Subject: Communications Report Transmittal #16
Comanche Peak Steam Electric Station
Independent Assessment Program - Phase 3
Texas Utilities Generating Company
Job. No. 84042

Communications Report

FIGURE 1
SUMMARY OF SUPPORT LOADS (GROUP C: WITH SNUBBERS)
UPSET MAXIMUM AND UPSET MINIMUM
VERTICAL SUPPORTS

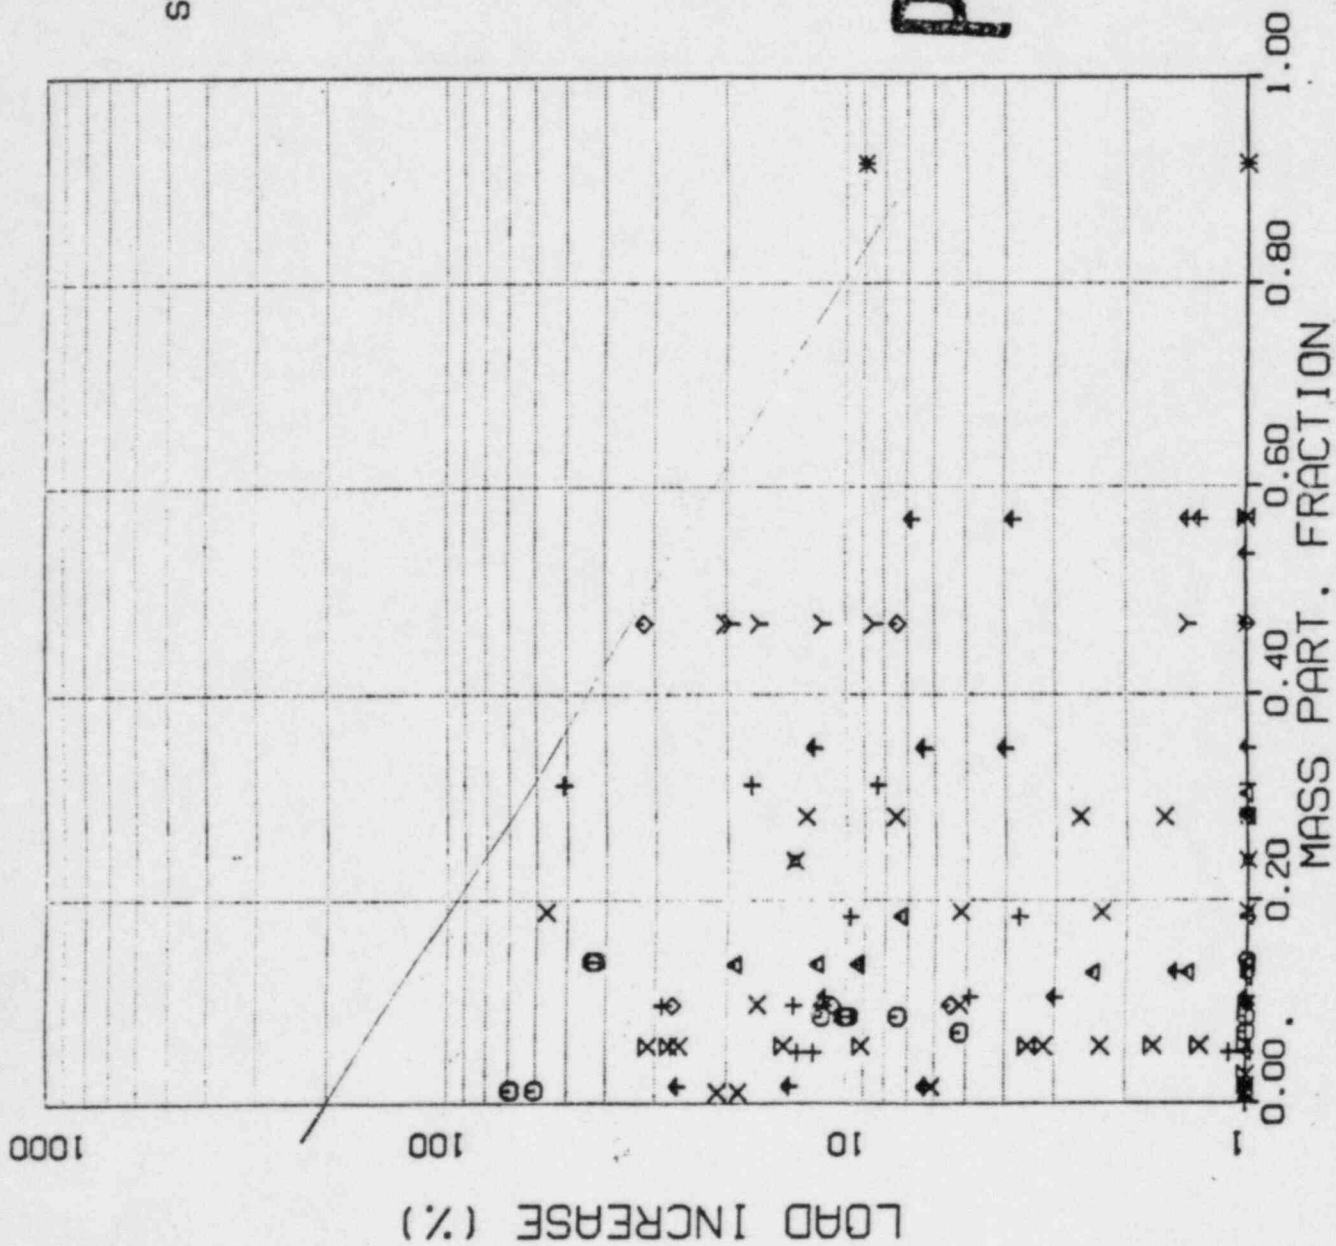
*what to decrease
would we accept?
i.e. what, upsets and*

FIGURE 3
SUMMARY OF SUPPORT LOADS (GROUP C: WITH SNUBBERS)
UPSET MAXIMUM AND UPSET MINIMUM
HORIZONTAL SUPPORTS

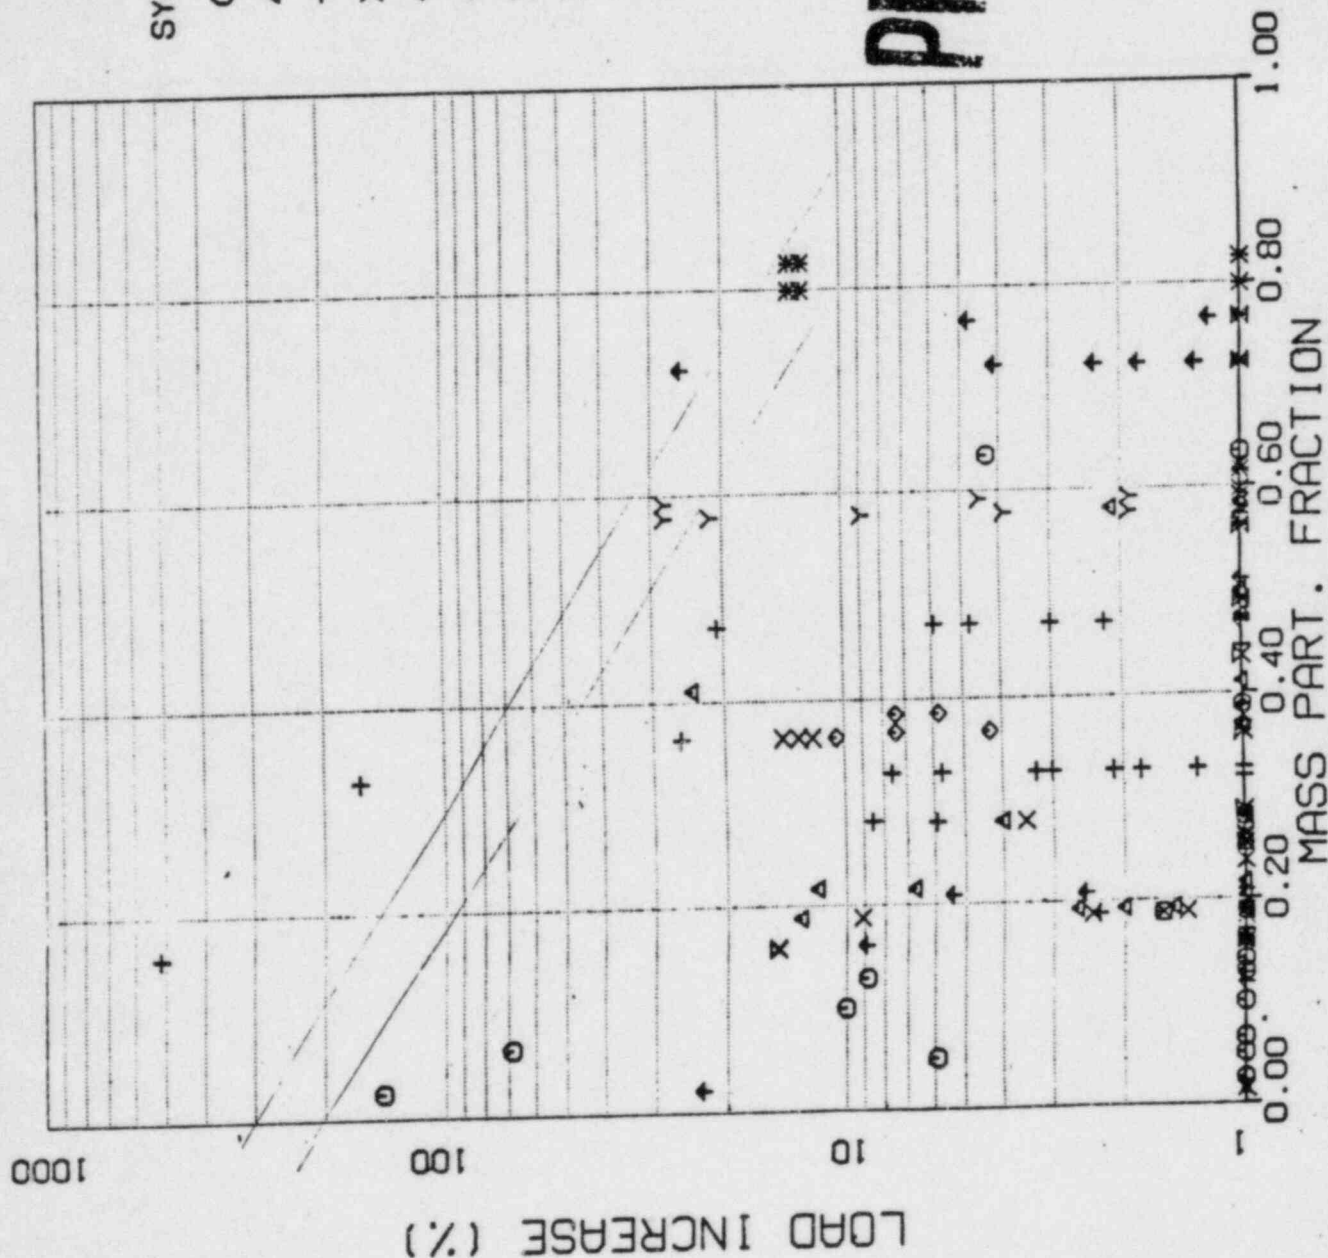
NOTE: SMALL (4")
HAVE INCR QUITE
A BIT (BUT THEY
HAD LOW MF)

FIG 5

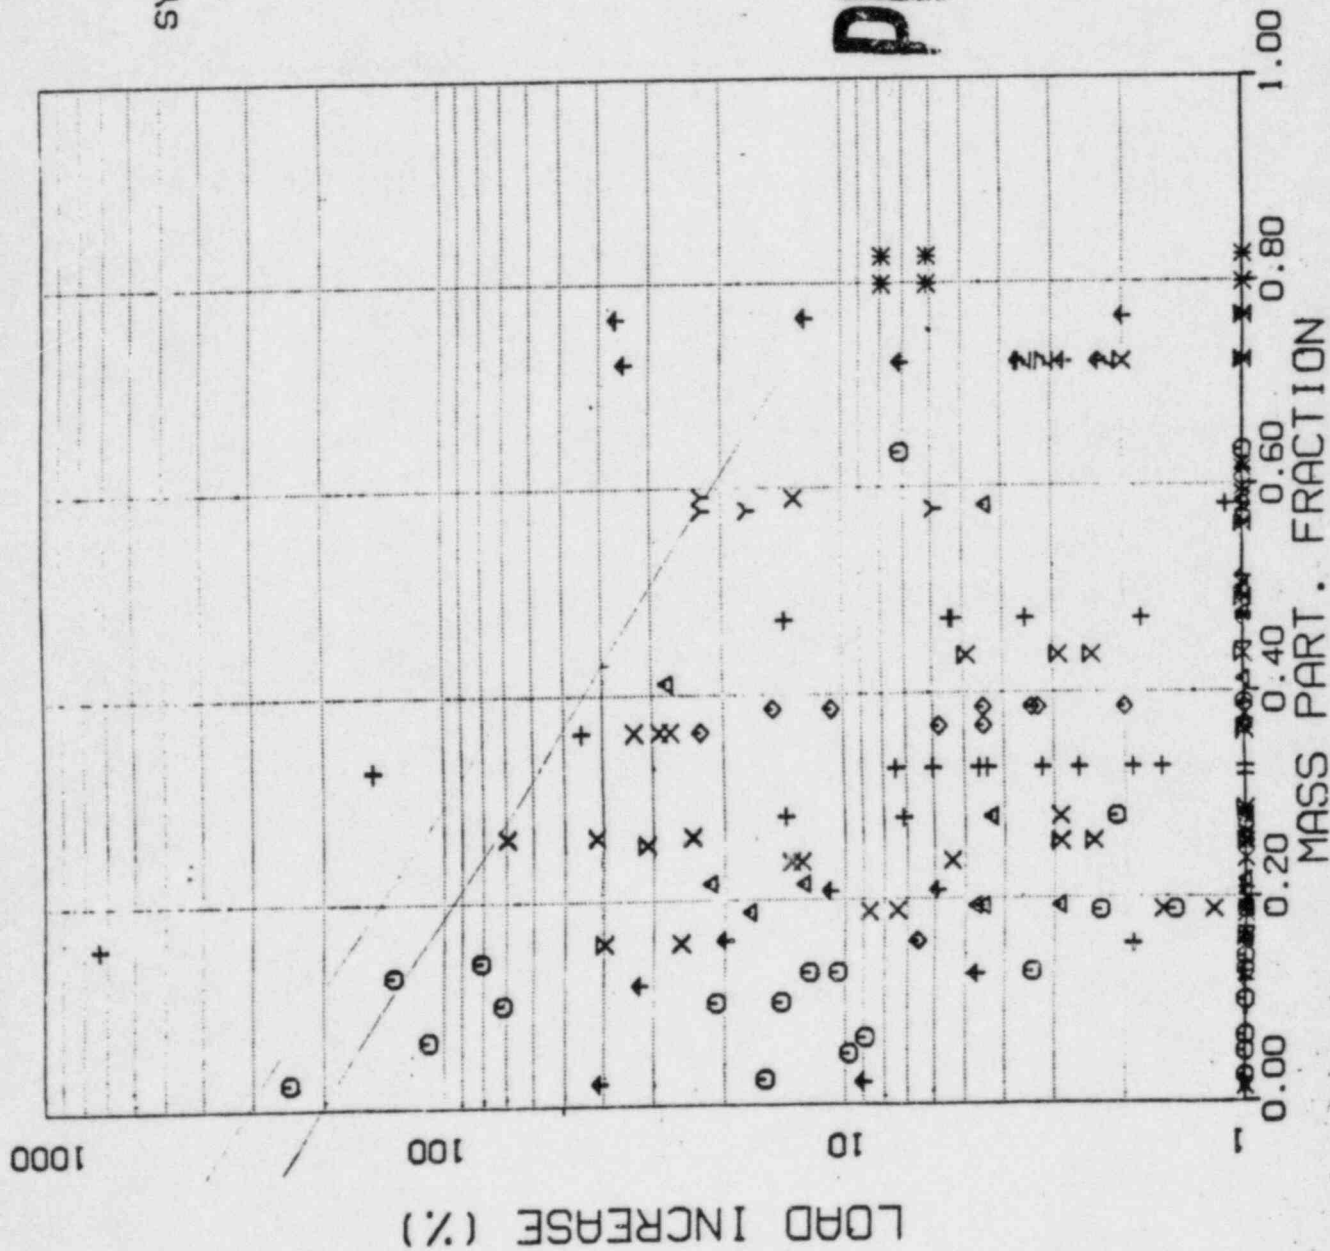
UPSET?
ENERG?
